VIRGINIA ELECTRIC AND POWER COMPANY
SURRY POWER STATION UNIT NOS. 1 AND 2
INSERVICE TESTING PROGRAM ANOMALIES

NRC SAFETY EVALUATION OF INSERVICE TESTING
PROGRAMS REV. 0 RESPONSES TO 1st PROGRAM ANOMALIES

**NRC SAFETY EVALUATION OF
SURRY UNITS 1 AND 2
INSERVICE TESTING PROGRAMS
REVISION 0**

SURRY UNIT 1
FIGURE 1

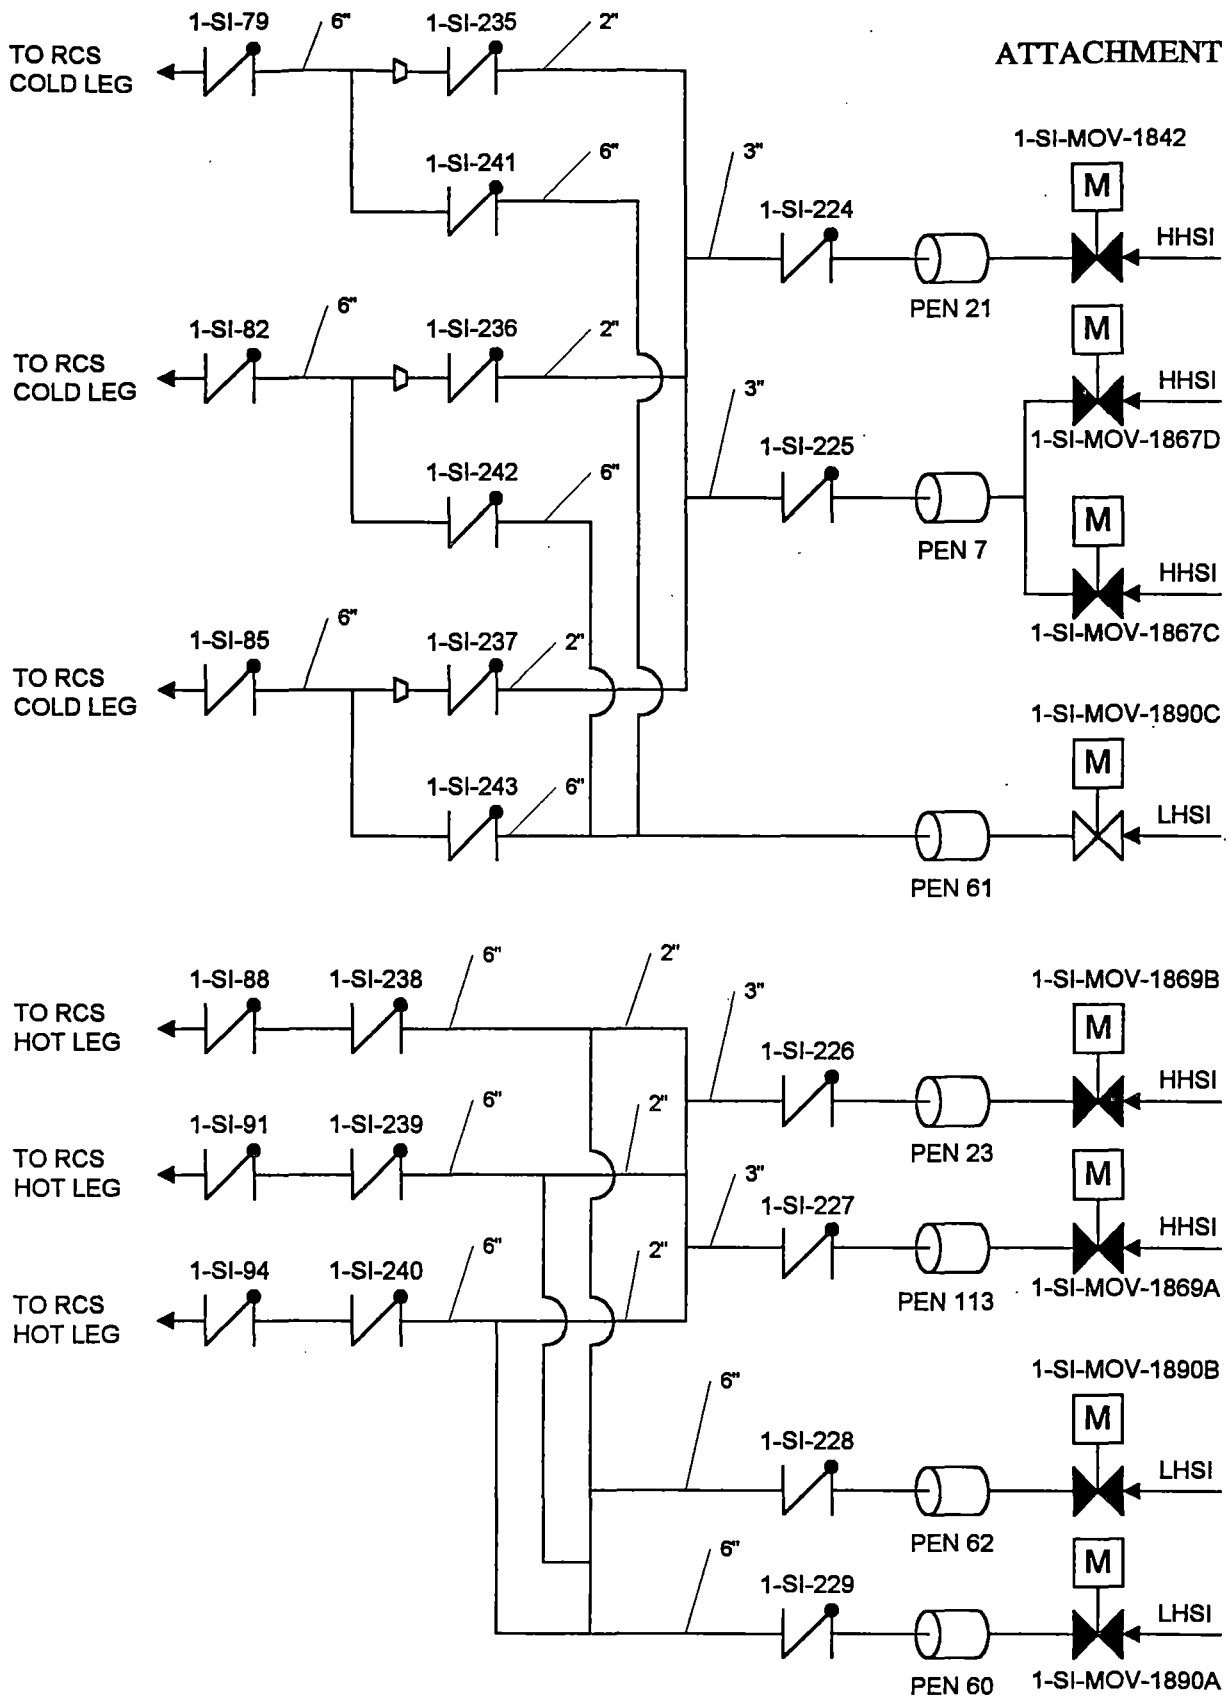
"The licensee's letter dated June 12, 1987, lists valves 1(2)-SI-79, 82, 85, 241, 242, and 243 as PIVs that are tested in accordance with the plant TS. These valves are in the injection headers to the RCS cold legs in an arrangement that is similar to the hot leg injection header valves in relief request V-27. It appears that the hot leg injection header check valves (1(2)-SI-88, 91, 94, 238, 239, and 240) perform an Event V pressure isolation function similar to the cold leg injection header check valves."

As shown in Figures 1 and 2, the valve configurations are different in that the pressure isolation valves (PIVs) listed in our Technical Specifications isolate penetration 61 from the RCS which has a normally open upstream motor operated valve (1(2)-SI-MOV-1890C). Valves 1(2)-SI-88, 91, 94, 238, 239, and 240 are downstream from penetrations 23, 60, 62 and 113 which are isolated by the normally closed upstream motor operated valves 1(2)-SI-MOV-1869A and B and 1(2)-SI-MOV-1890A and B. This configuration is not an Event V configuration as confirmed by the Safety Evaluation Report for Surry Power Station entitled "PRIMARY COOLANT SYSTEM PRESSURE ISOLATION VALVES (WASH-1400, EVENT V)", dated April 20, 1981 which concluded that, "the valve configurations of concern have been correctly identified." There is no need for further evaluation of Event V configurations as suggested by the discussion in Anomaly 14.
